**Remedial Investigation and  
Feasibility Study Work Plan  
Revision 2**

Nevada Environmental Response  
Trust Site; Henderson, Nevada

*Date:*  
**June 19, 2014**

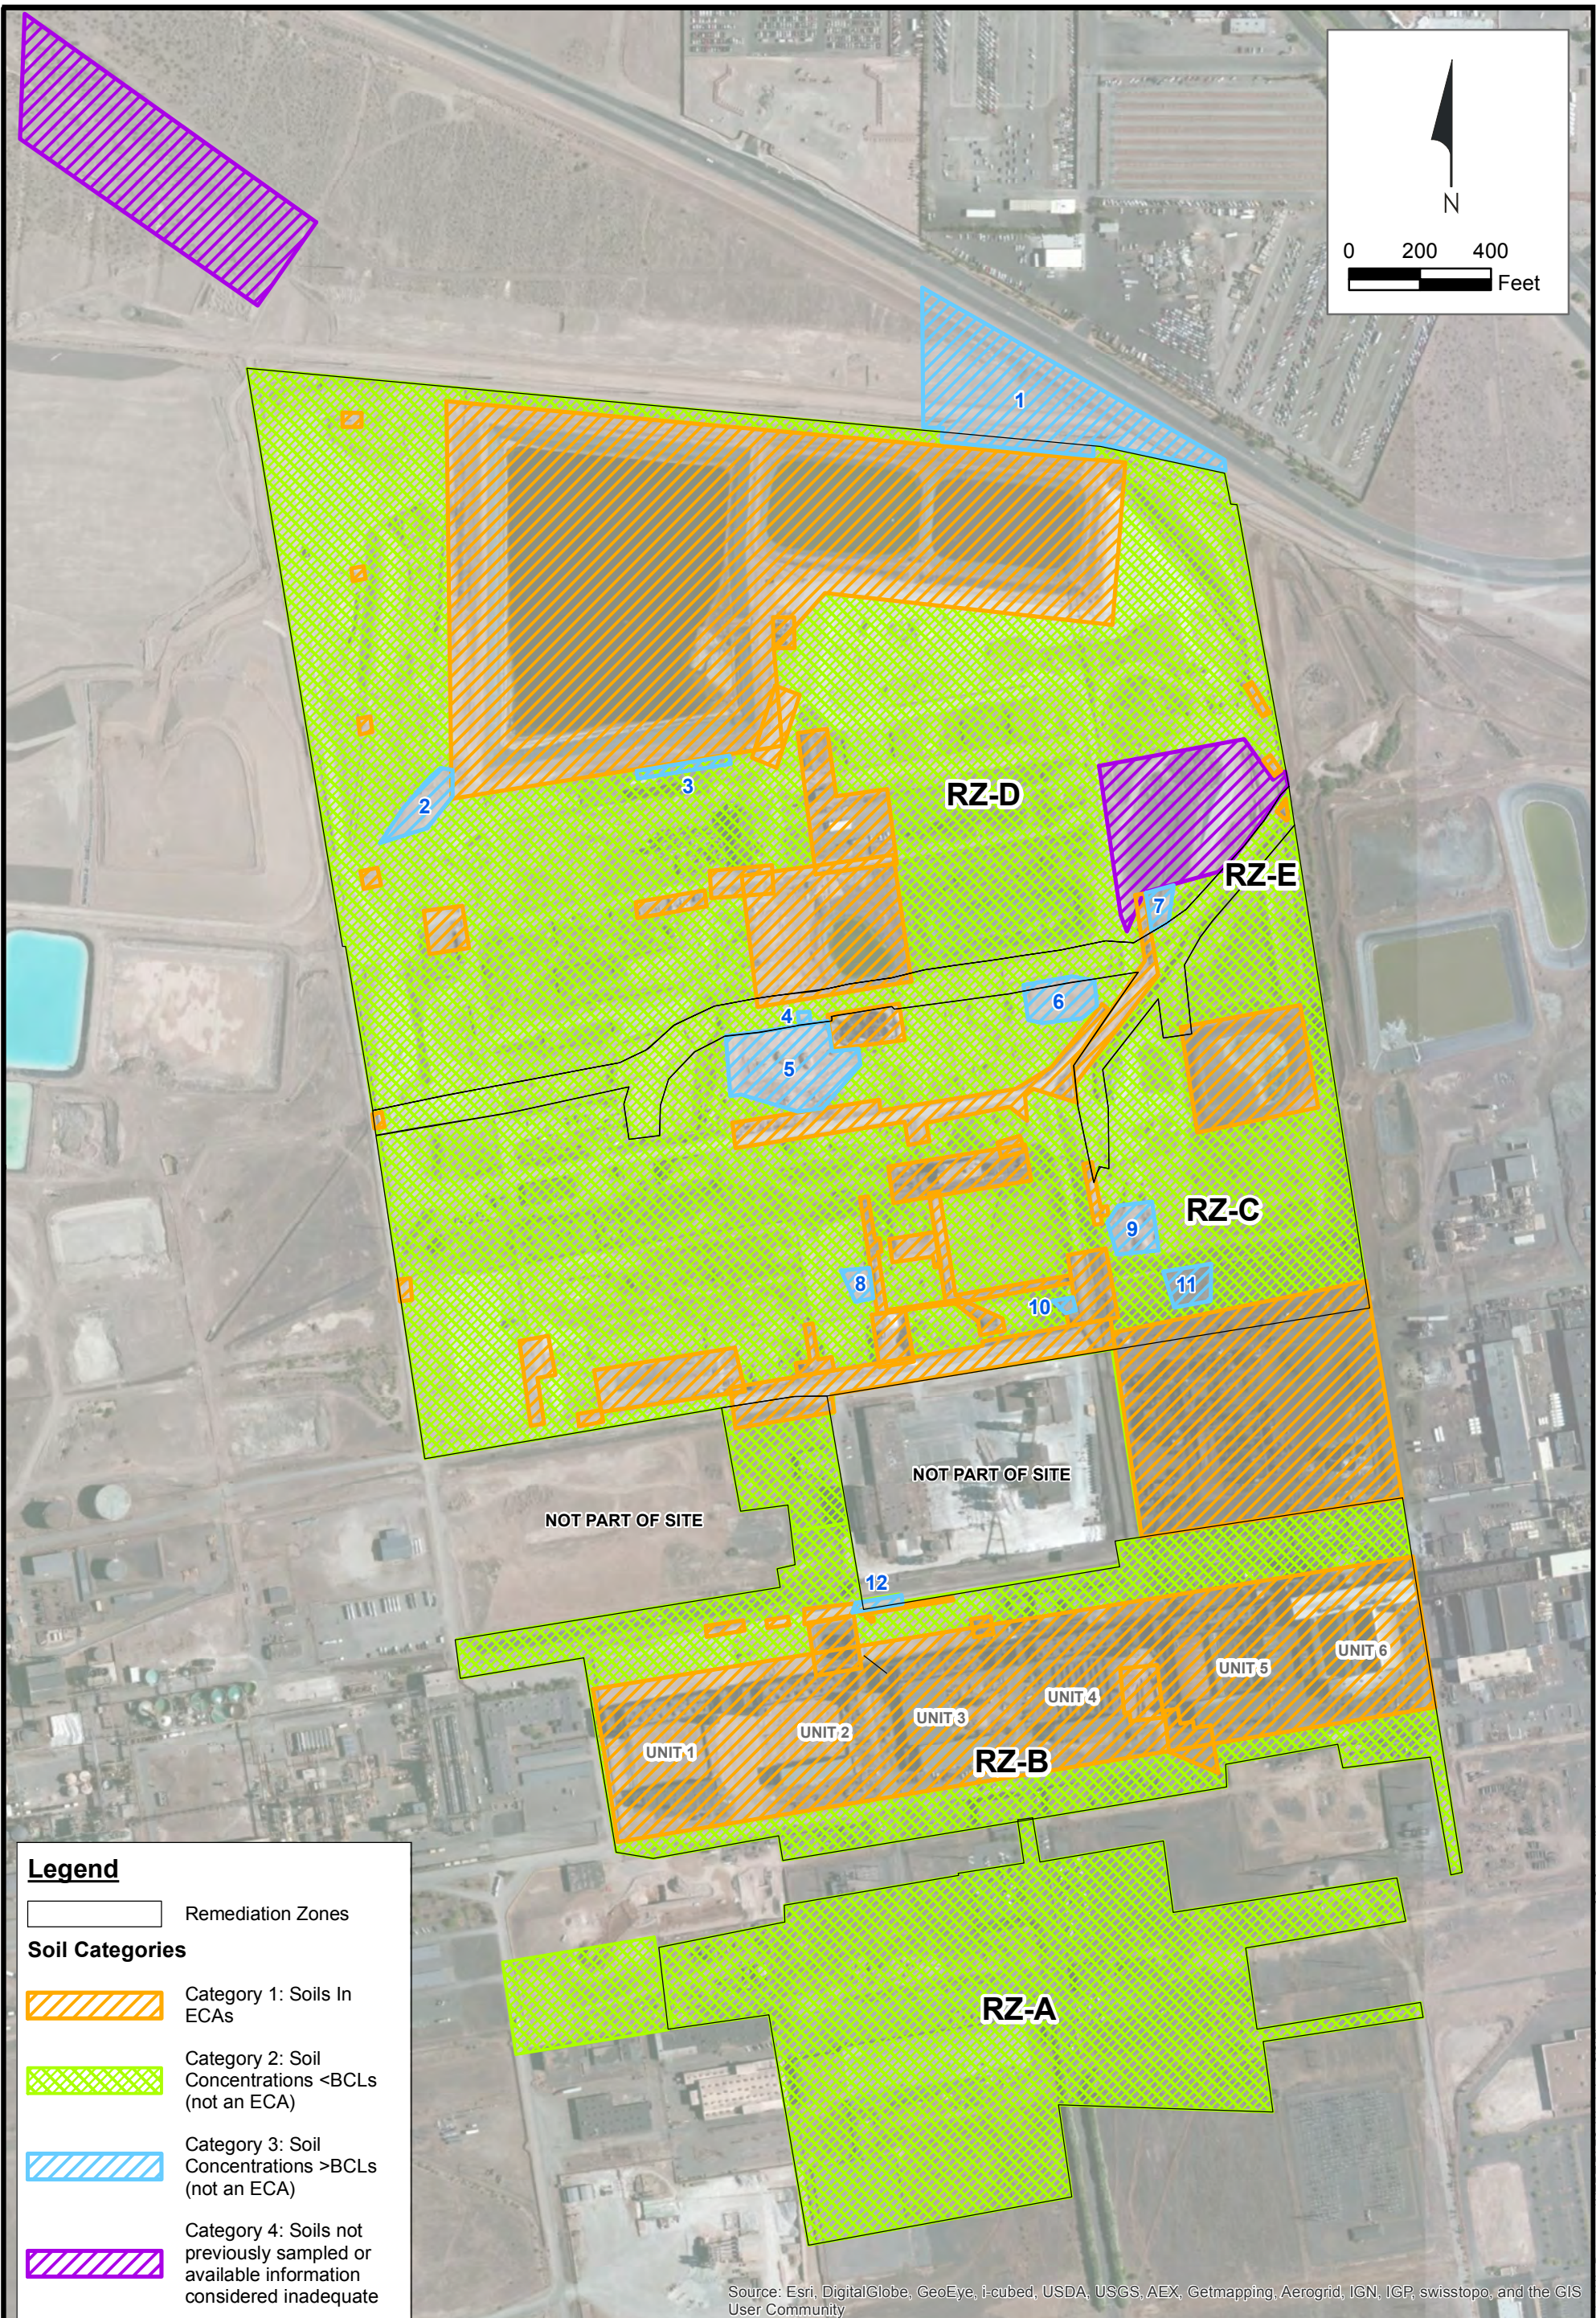
75. Figure 5-2 Historical and Active Pond Locations, the depiction of the Northwest Ditch is inconsistent with what NDEP has seen previously. Please provide a citation for this depiction and discuss with NDEP or revise as necessary.	<p>The depiction of the Northwest Ditch on Figure 5-2 of the RI/FS Work Plan was based on Figure 4-1 of the <i>Phase A Source Area Investigation Results</i> (ENSR 2008a) and Figure 5-2 of the <i>Phase B Source Area Investigation Results, Soil Gas Survey Work Plan</i> (ENSR 2008b).</p> <p>In response to NDEP's comment, ENVIRON reviewed historical reports prepared for the site and other BMI properties. Reports prepared for the TIMET site (Tetra Tech 2005, TIMET 2013) provided additional information on the current locations of the Beta Ditch and Northwest Ditch on the TIMET property as well as the ditch configurations from pre-1955 through 1979. A revised Figure 5-2, incorporating this information, will be provided in the revised RI/FS Work Plan.</p> <p>We note that the locations of the Northwest and Beta Ditches <i>within</i> the site boundary that were shown on Figure 5-2 of the Work Plan are consistent with the ditch locations shown on figures from earlier reports. Thus, ditch locations within the site to be depicted on the revised Figure 5-2 will not change.</p>

**Remedial Investigation and Feasibility Study Schedule**  
 Nevada Environmental Response Trust Site  
 Henderson, Nevada  
 Drafter: KPL Date: 6/17/2014

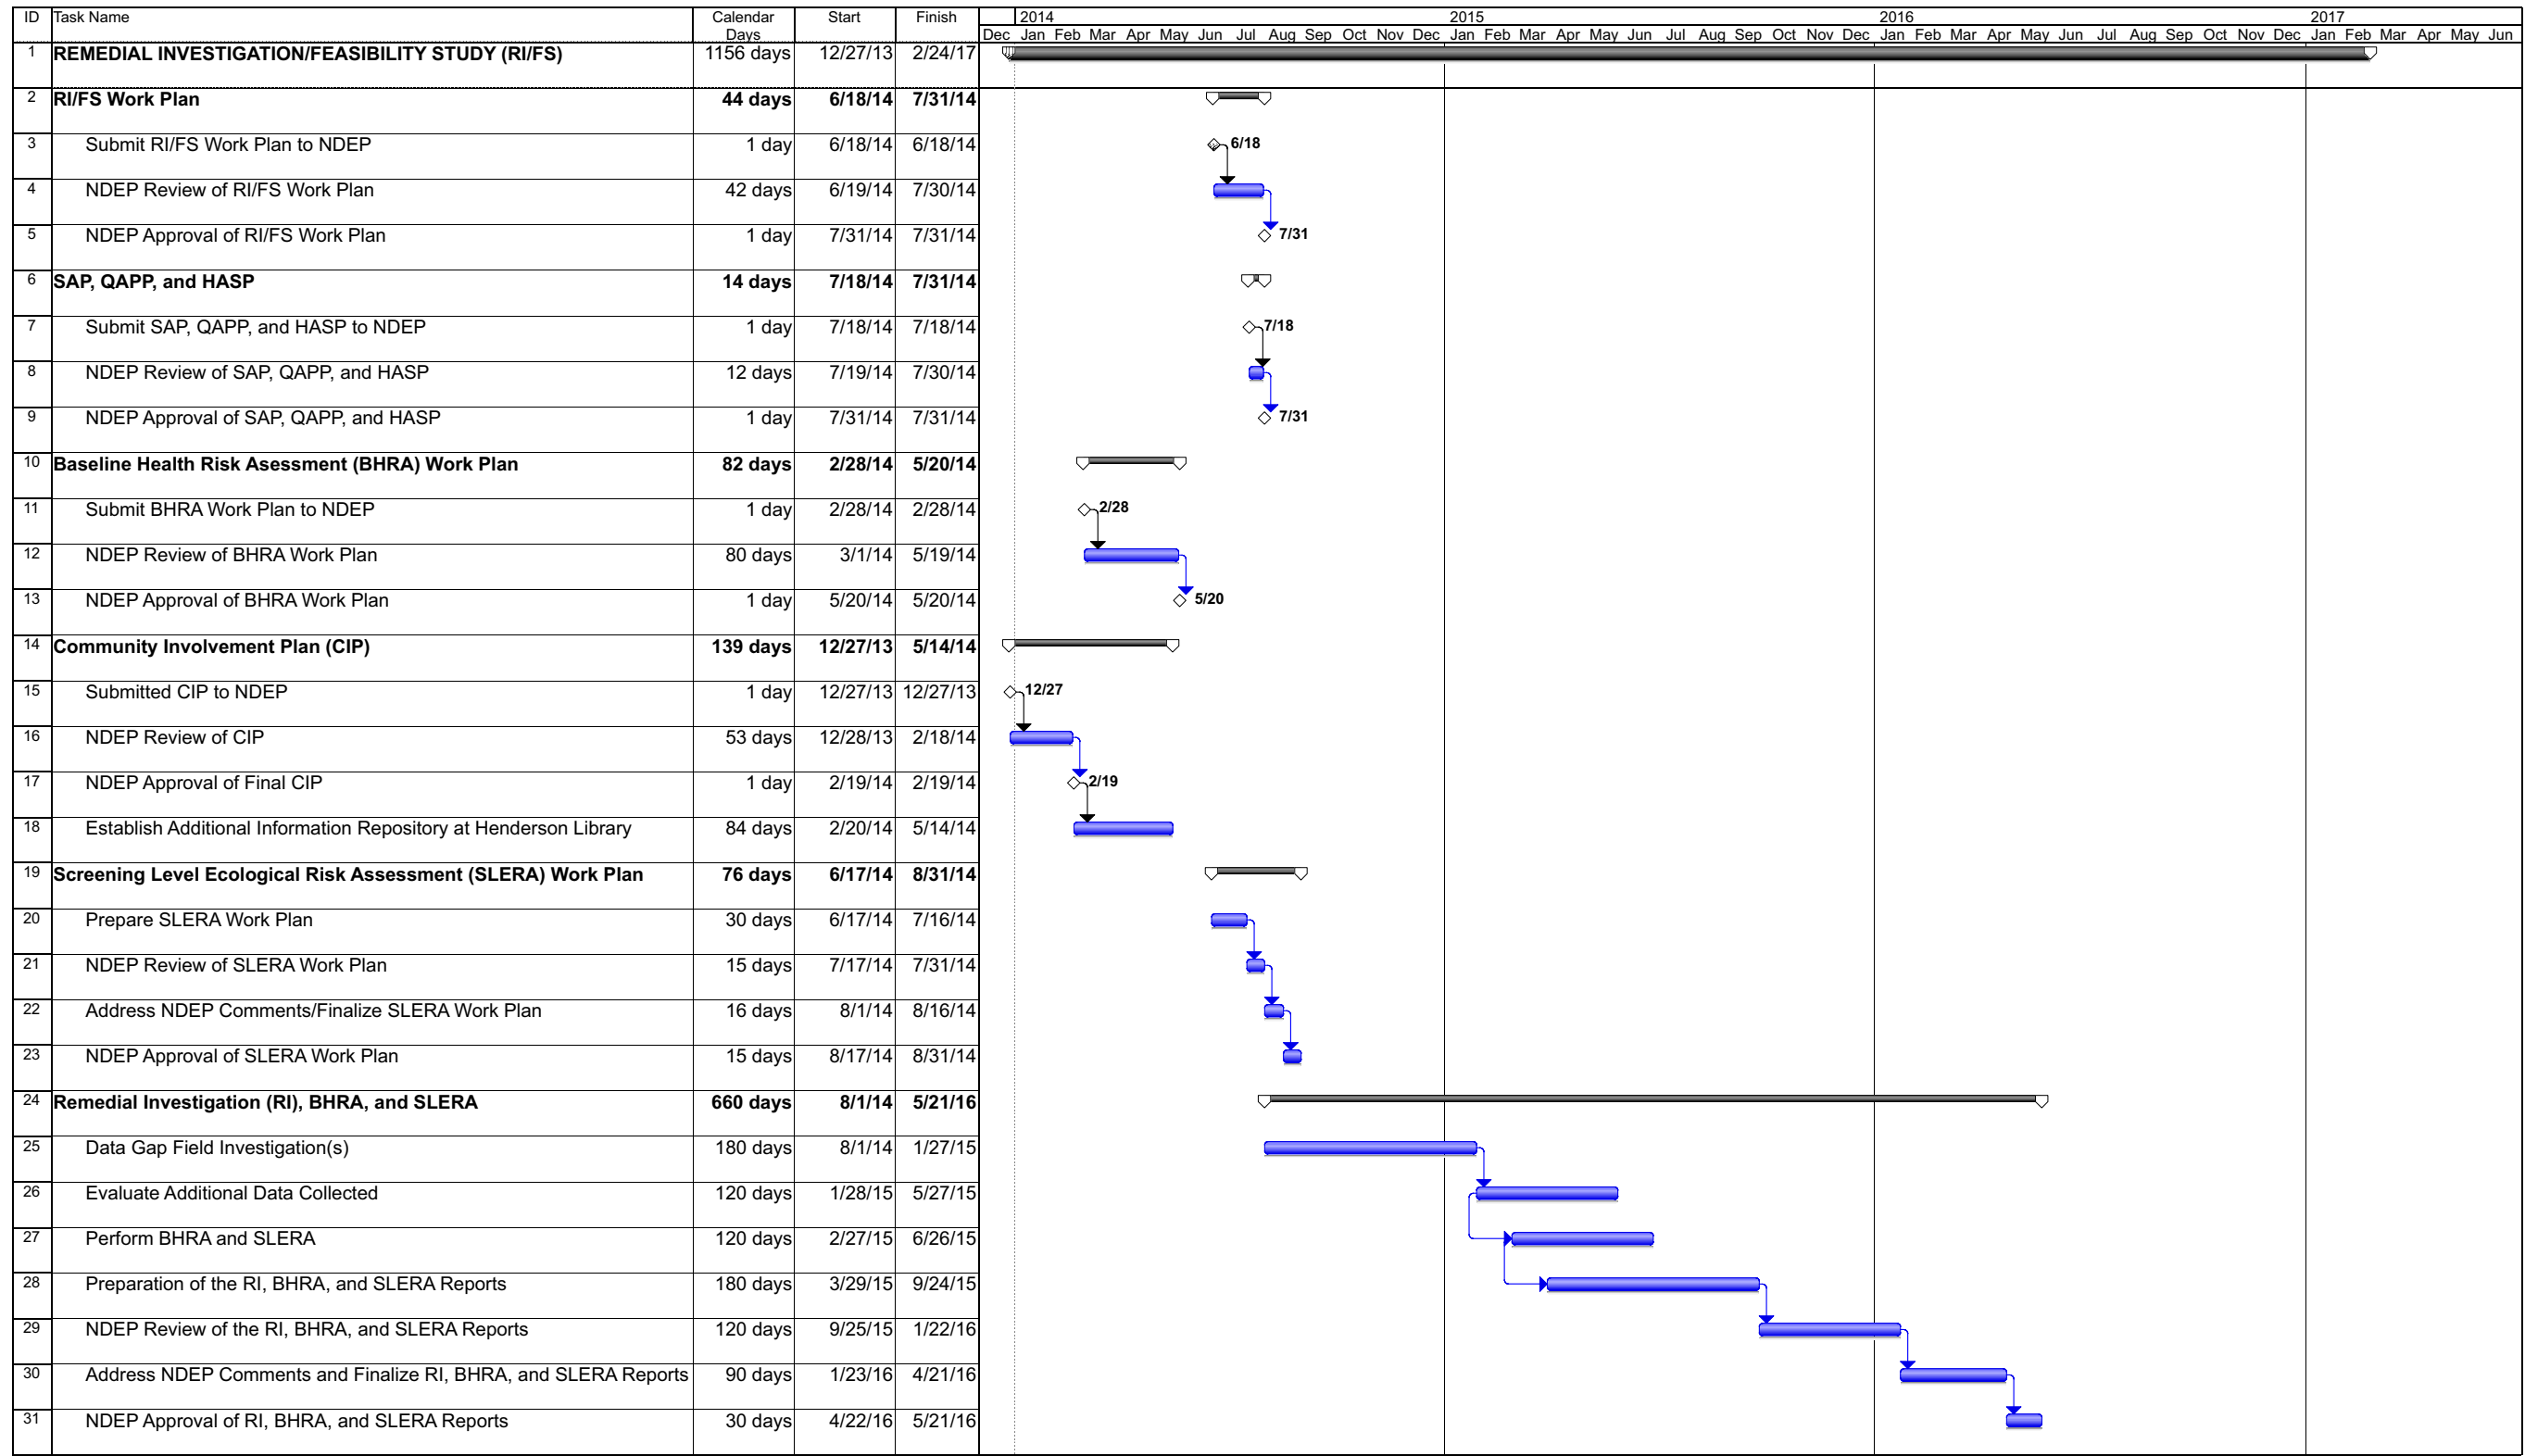
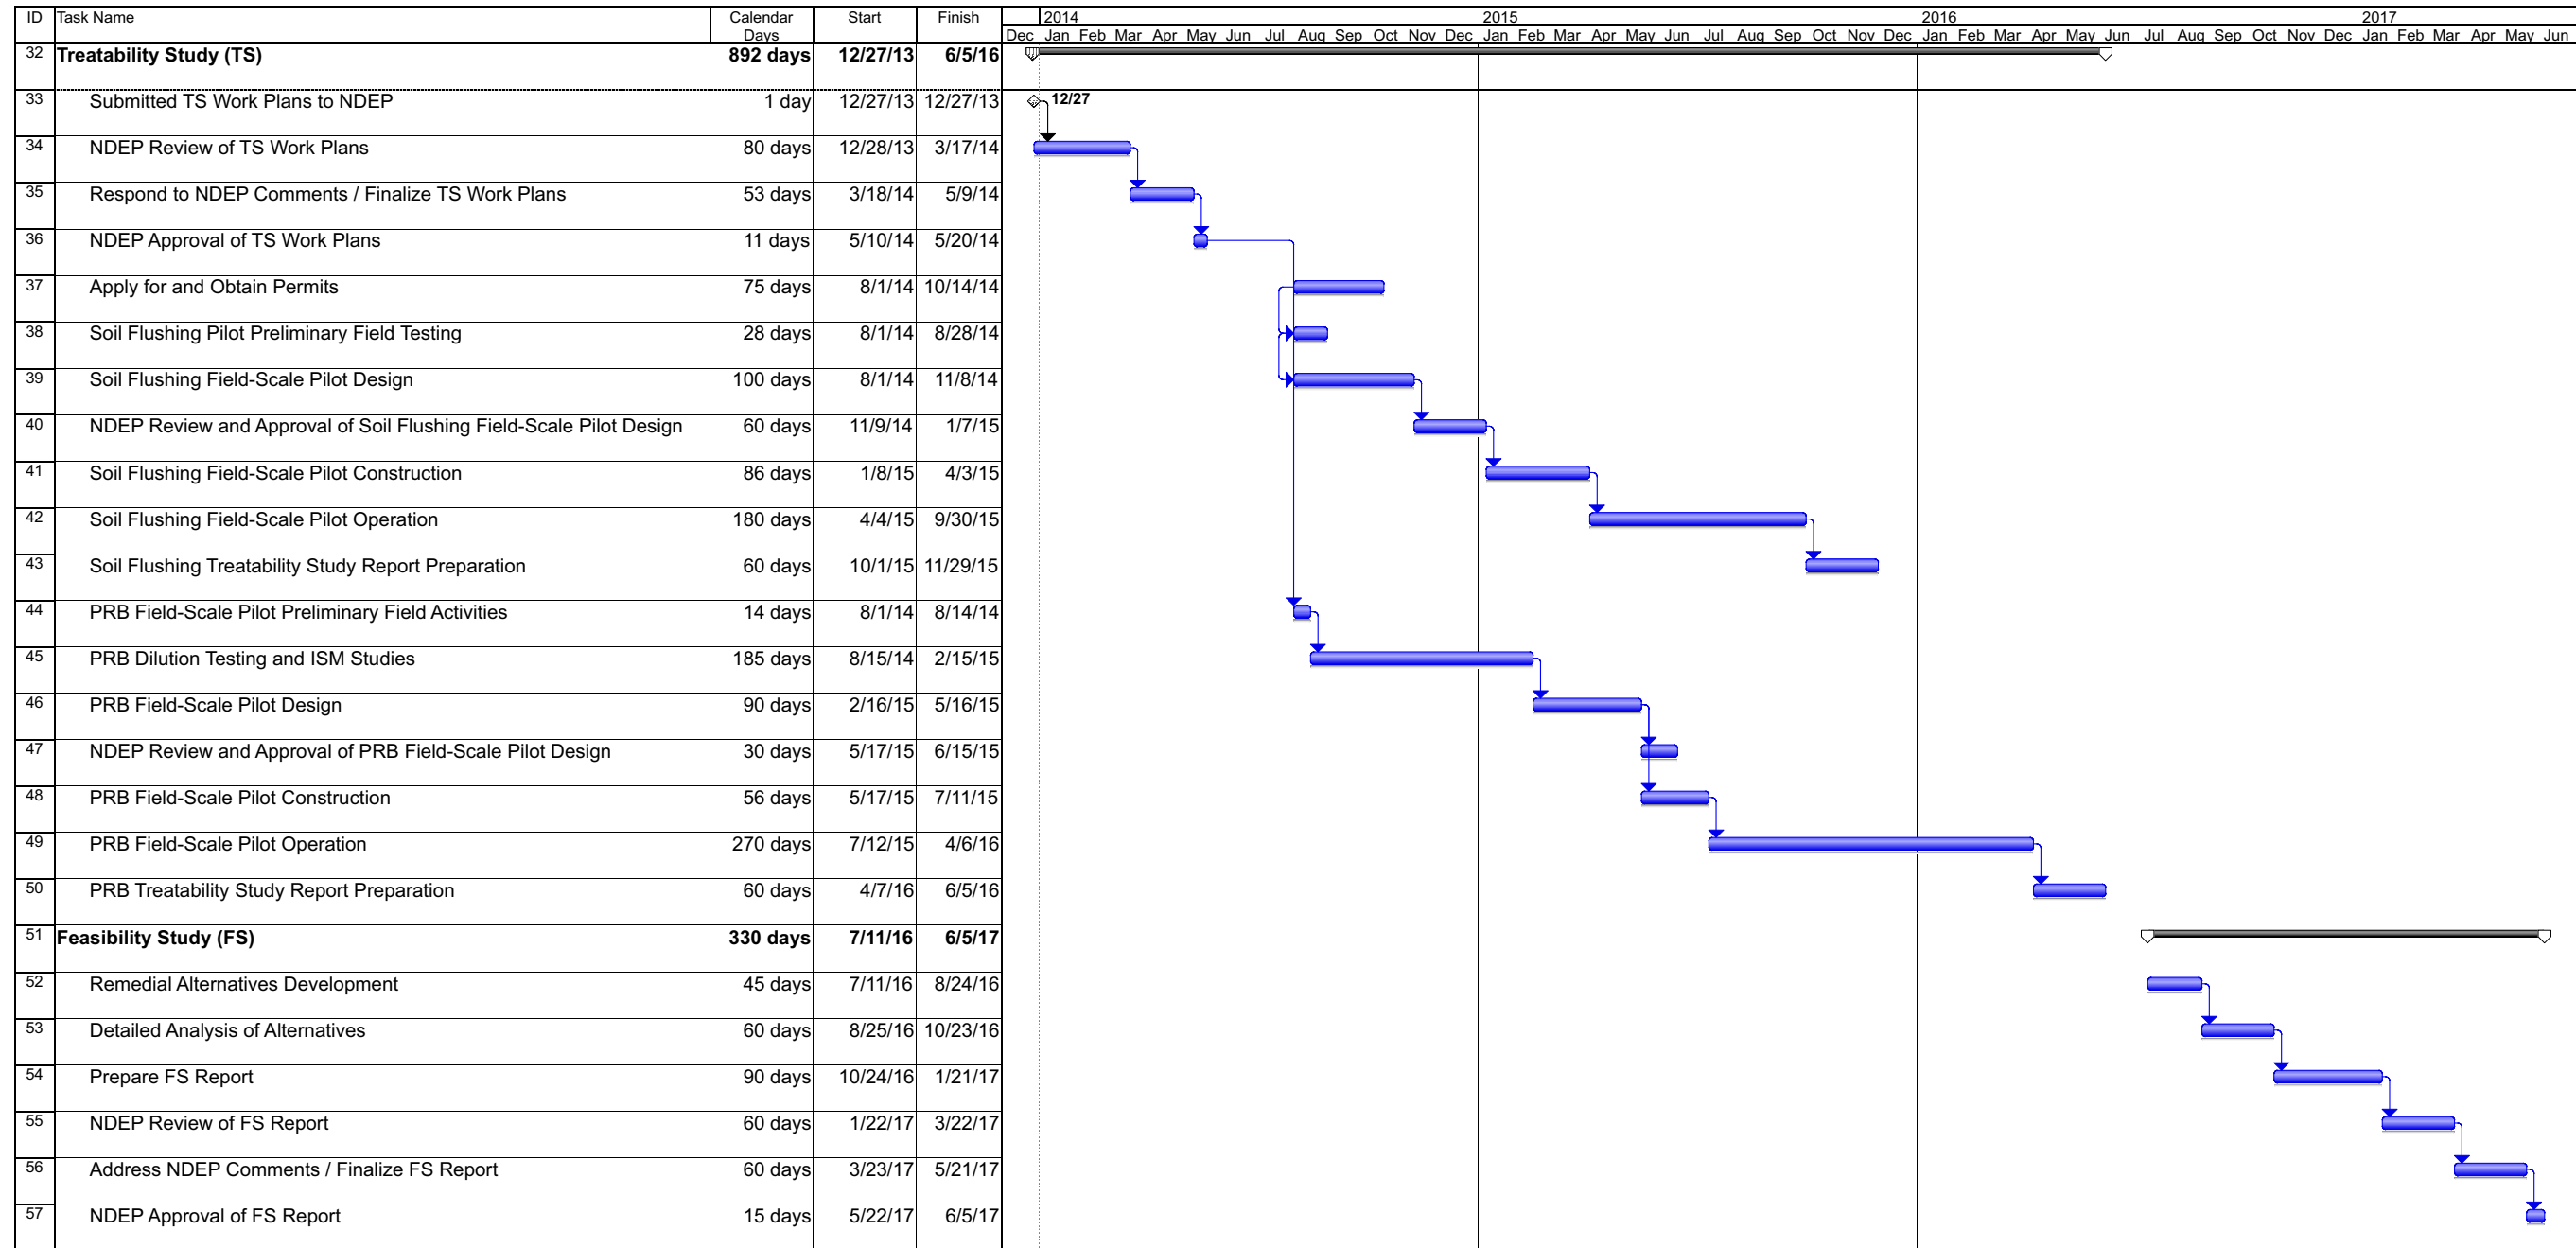
80. Figure 7-1 Remedial Investigation and Feasibility Study Schedule, this figure presents a timeline for a baseline HRA work plan. Please clarify whether the Trust plans on submitting a new HRA work plan or revise the existing one (Northgate 2010).	See response to Comment #5.
